Staff Report to the
Municipal Planning Board
July 21, 2020

ZON2020-10007

2113 E. SOUTH ST. PD

Site Plan

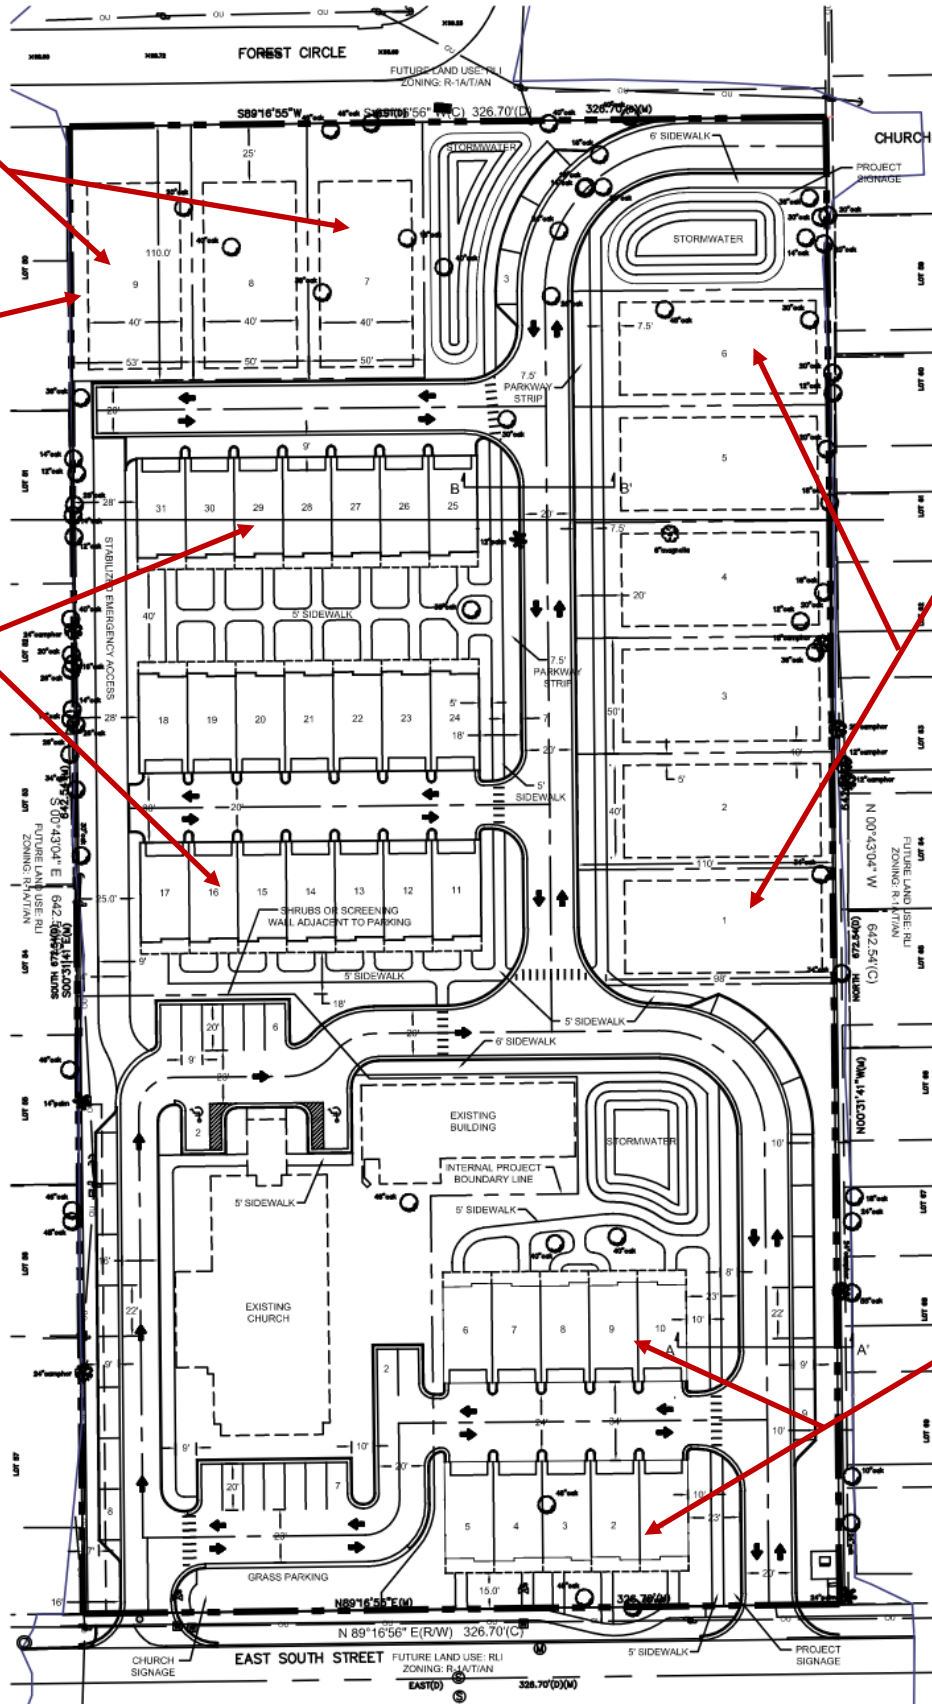
In order to best accommodate the uses on the property, staff is recommending the development standards identified below. Staff is supportive of 50 ft. wide lots where 70 ft. is typically required in the R-1A zoning district as well as the reduced setbacks identified below. A minimum lot depth of 110 ft. is required for the single-family homes, however, Lot 1 may be able to be reduced to 100 ft. to accommodate the curvature of the private drive along the southwest corner of the lot. Additionally, lots 7-9 of the single family must be rear loaded onto the private alley as to limit traffic on Forest Circle. A Bufferyard 'A' will be required along the western property line and the eastern property line south of lots 1-6 of the single family homes to best integrate the development into the community. Lastly, the applicant has expressed interest in detached garages, where not outlined below the City's accessory structure code applies. A Final Site Plan Determination will be required prior to submitting for permits to ensure the proposed plans meet the regulations set forth in the PD and the conditions of this staff report.

7.5 ft. Setback
Required

8. **Lots 1-6 Setbacks.** Lots 1-6 are must have a minimum front yard setback of 20 ft., a rear setback of 20 ft., and a side yard setback of 5 ft.
9. **Lots 7-9 Setbacks.** Lots 7-9 must have a minimum front yard setback of 25 ft. and a side yard setback of 5 ft. provided that Lot 9 must have a minimum western setback of 7. 5 ft. All garages must be setback 5 ft. or greater than 16 ft. from the alley. The portion of the home that isn't garage must be setback 20 ft. from the alley (as depicted in Lot Type "C").

Landscape / Tree Removal Plan

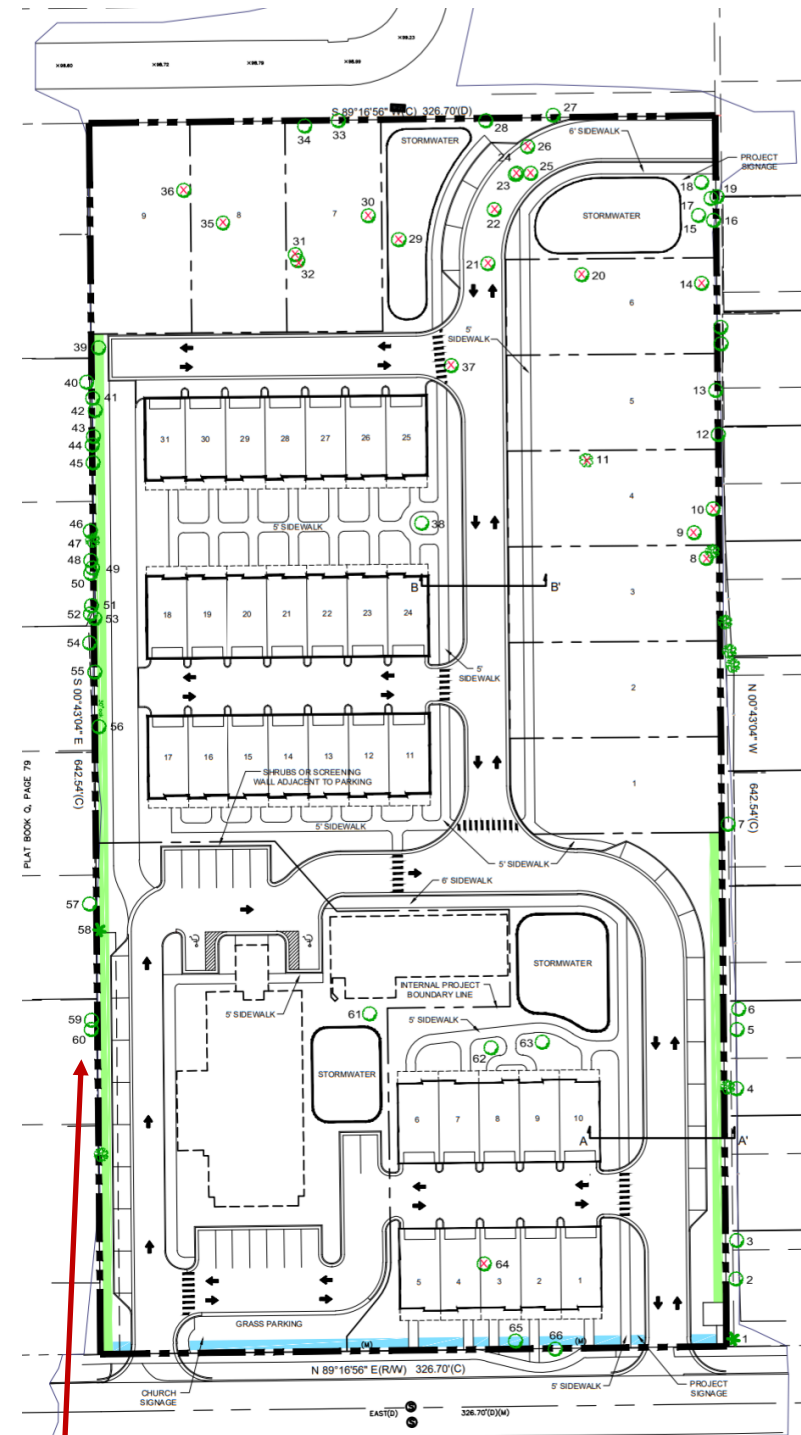
Bufferyard A
Required

17. **Townhomes.** Unless where specified in this report, townhomes must meet Chapter 58 Part 3B on Townhome Development.
18. **Bufferyard.** A bufferyard 'A' is required along the western property line and along the eastern property line, adjacent to the parallel parking spaces.

Streetscape Cross Sections

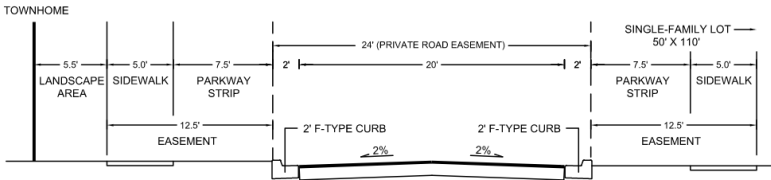
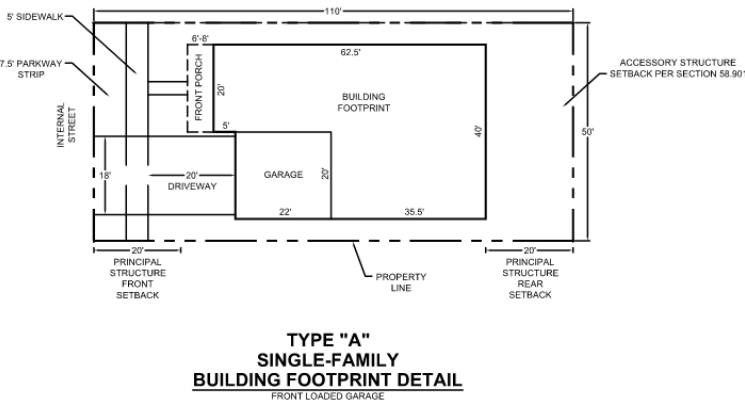
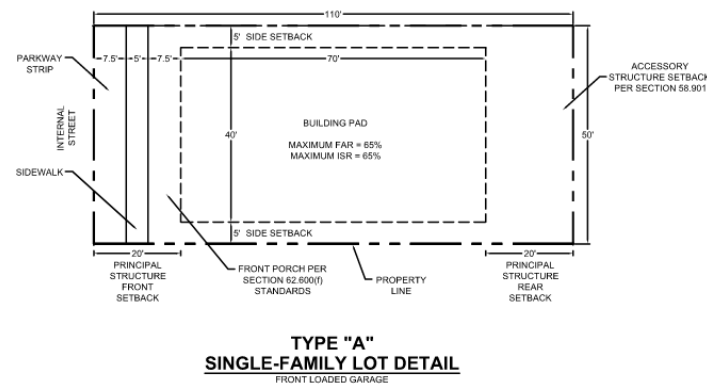
Private Drives Must
Comply with City
Standards

9. The whole street section must be in the private road easement, including the parallel parking, sidewalks and landscaping strip which must contain street trees.

10. All parallel parking lanes must be 8' wide. Where Type F curb is present, up to 1' of the 8' width must be included in the gutter.
 11. When the sidewalk is adjacent to the vehicular travel lane a curb must be used, vertical, type D or type F.

TYPE "C"
SINGLE-FAMILY BUILDING FOOTPRINT DETAIL
REAR LOADED GARAGE

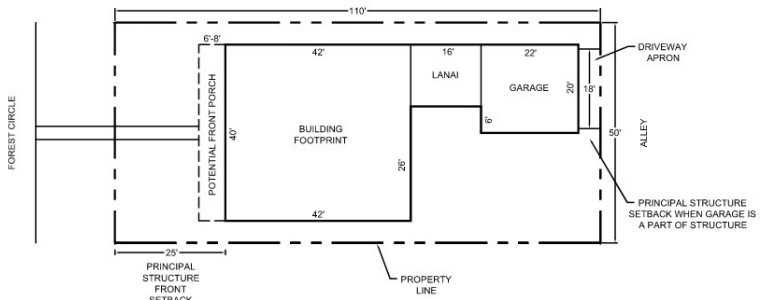
Portion of home that requires a rear yard setback of 20 ft.
